SERVICE BULLETIN M20-66

DATE: 4-18-60  
 SUBJECT: P/N 3087 INSPECTION AND REPAIR INSTRUCTIONS  
 MODELS AFFECTED: M-20 AND M-20A. ALL SERIAL NUMBERS  
 TIME OF COMPLIANCE: AS SOON AS POSSIBLE BUT NOT LATER THAN THE NEXT PERIODIC INSPECTION AND AT SUBSEQUENT 12-MONTH INTERVALS. THIS INSPECTION MAY BE DISCONTINUED IF KIT S.L. 20-66 IS INSTALLED.

Figure 1 (a)

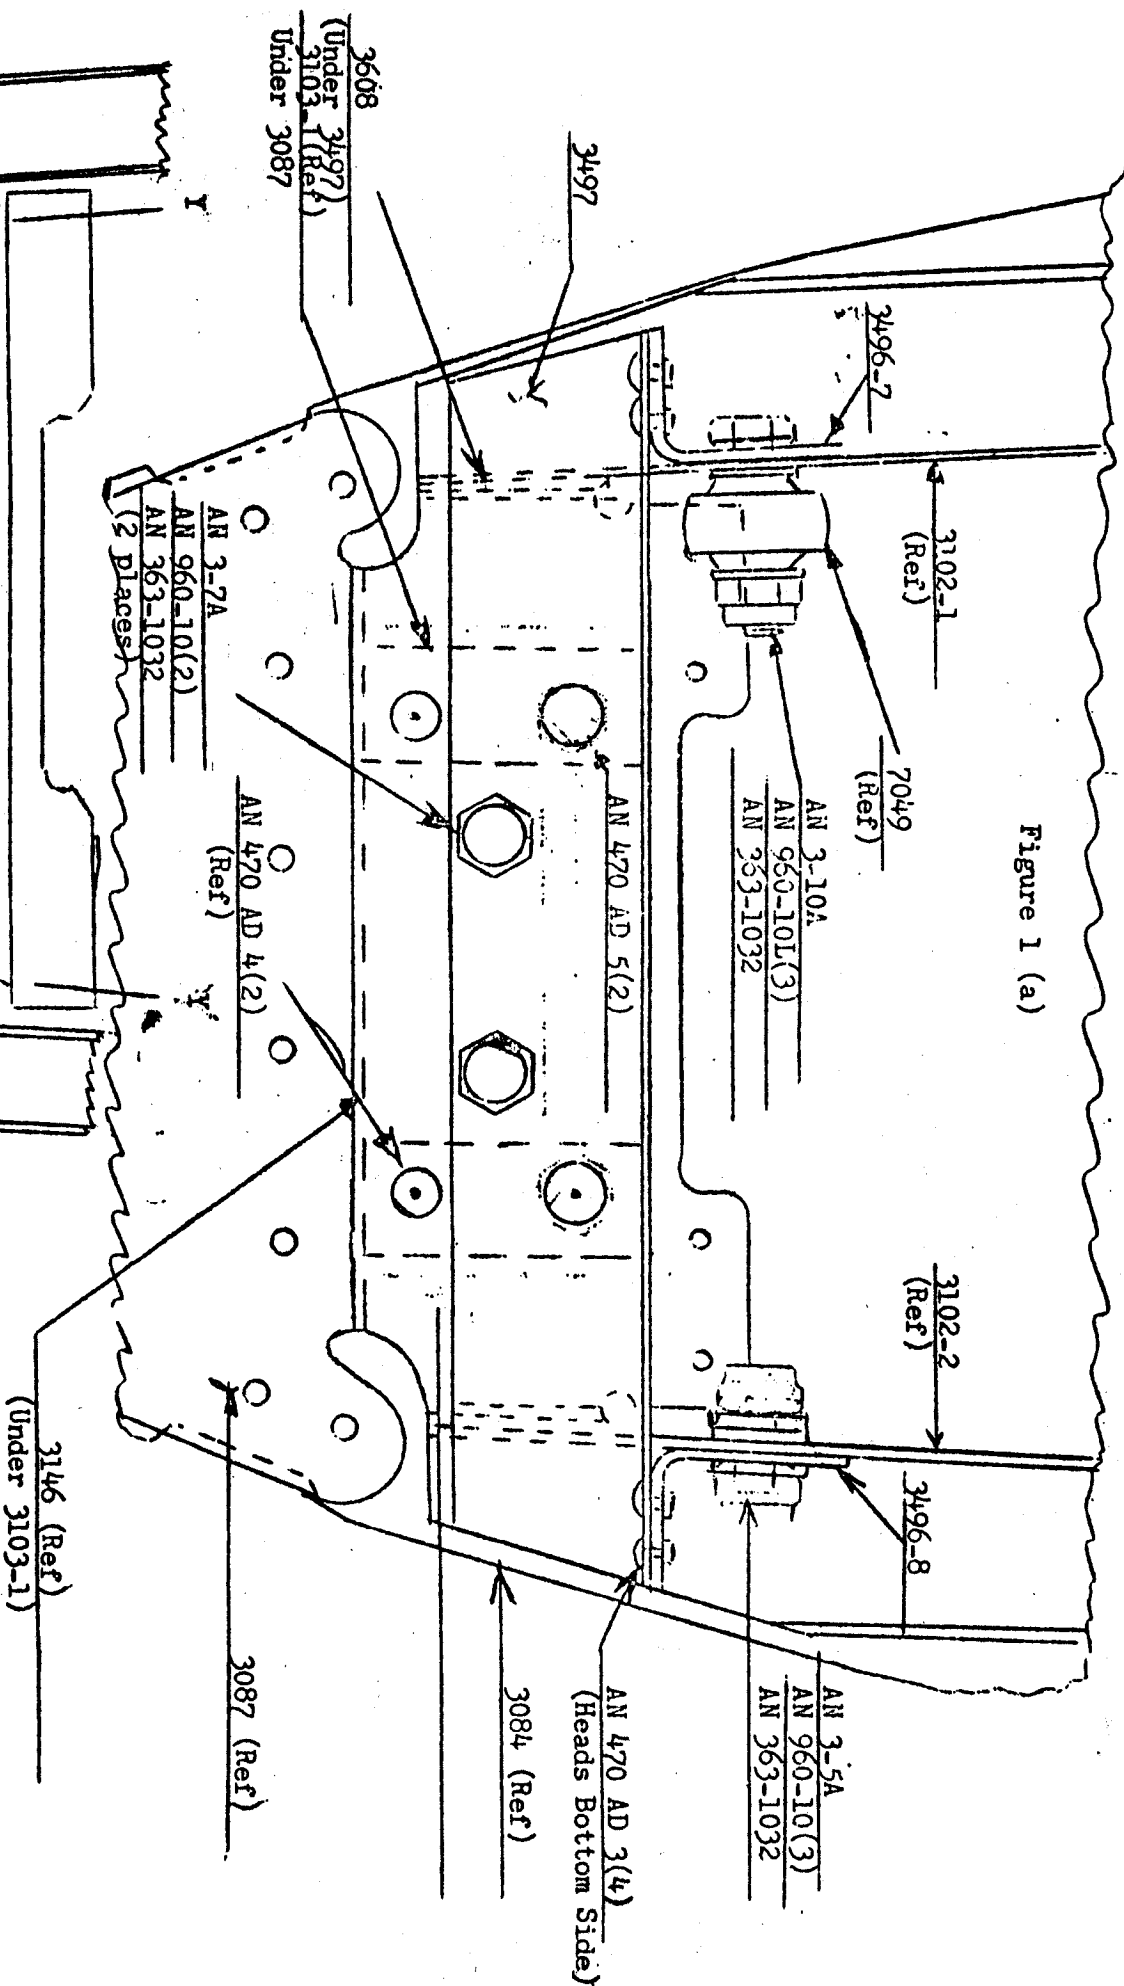
- b. If crack is outboard of line Y-Y and is 3/16 inches or less in length, it may be stop drilled with a 1/32 to 3/64 diameter drill and P/N 3087 repaired in accordance with the following instructions. (Items 2-10) & (Figure 1 (a)).

2. Remove stinger.
3. Remove empennage (detaching P/N 7049 link at the bulkhead).
4. Detach P/N 3146 (bracket holding P/N 7107) from P/N 3087.
5. Drill out top two rivets (AN 470 AD4) attaching P/N 3103-1 to P/N 3087.

6. Bolt P/N 3608 and P/N 3497 in place using the two lower AN 3 bolts.
7. Check hole alignment and drill out to #20(.161)D the two #30 diameter holes thru P/N 3497, 3608, 3087, and 3103-1 and install the two AN 470 AD5 rivets.

8. Locate P/N 3496-7 with the top edge even with the aft edge of flange on P/N 3497 and bearing flat against P/N 3497 and P/N 3102-1. Drill out 3/32 D holes (2) in P/N 3496-7 and thru P/N 3497 to #40(.098). Install AN 470 AD3 rivet (2). Drill #12(.189)D hole in P/N 3496-7 to match hole in P/N 3102-1. Install P/N 3496-8 in a similar manner drilling out the 1/8D hole in P/N 3496-8 and thru P/N 3102-2 to a #12(.189)D for the AN 3-5A bolt.

9. Attach P/N 3146 and P/N 7107 removed in item 4.
10. Install empennage. Attach P/N 7049 to bulkhead with hardware shown picking up P/N 3496-7 with bolt. Install remaining parts.

Figure 1 (b)

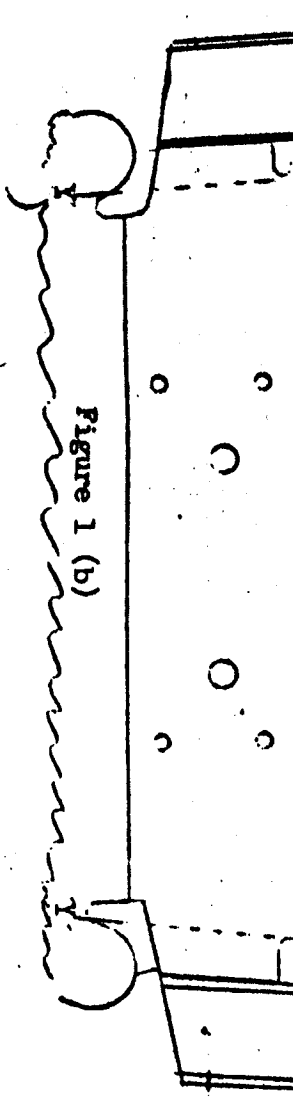
INSPECTION - (See Figure 1 (b))

1. Remove P/N 3273 fairings (both sides) between tail cone and stinger.
2. Remove dirt and inspect P/N 3087 in the bend radius just outboard of line Y-Y for cracks using a ten power glass. If cracks are found, replace or repair P/N 3087. See instructions below. Kit S.L. 20-66 (P/N 3496-7 & -8, 3497, 3608, and hardware) is available at no cost from the Spare Parts Department, Mooney Aircraft, Inc., Box 72, Kerrville, Texas. Give airplane serial or registration number with order.
3. Please complete and return the enclosed compliance card.

1. The following procedure applies if cracks are found in P/N 3087. See Figure 1 (b).
  - a. If crack extends inboard of line Y-Y or is longer than 3/16 of an inch, replace P/N 3087.
